**Region A Headquarters**  
**56 Game Farm Road, Gray ME 04039**  
**ADDENDUM NUMBER 2**  
**October 7, 2016**

**Region A Headquarters, dated August 29, 2016**

**C** DRIP EDGE SECTION (INFILTRATION)  
N.T.S.

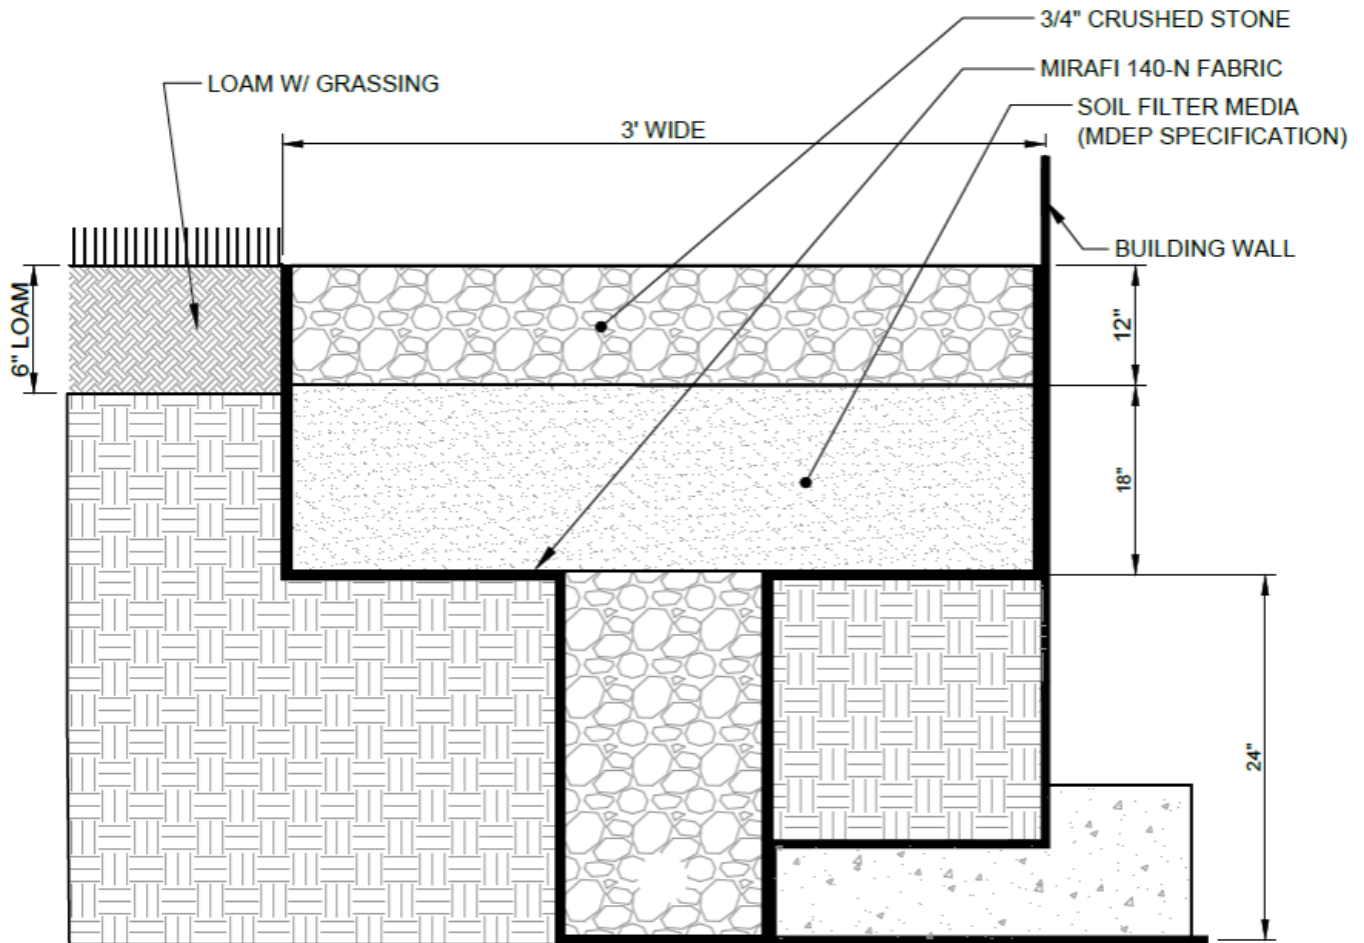
1. CSK-1 Drip Edge Section

**Answer:** Access gate to be installed by owner.
9. **Question:** New concrete curb 8' lengths or slipform?  
**Answer:** See question 4 Addendum 1.
10. **Question:** Drip edge details

**Answer:** See attached SKC-1
11. **Question:** New bunkhouse has bathroom. How does sewer get to disposal field?  
Pump station and tank?)  
**Answer:** Separate drainage field to be installed by owner n
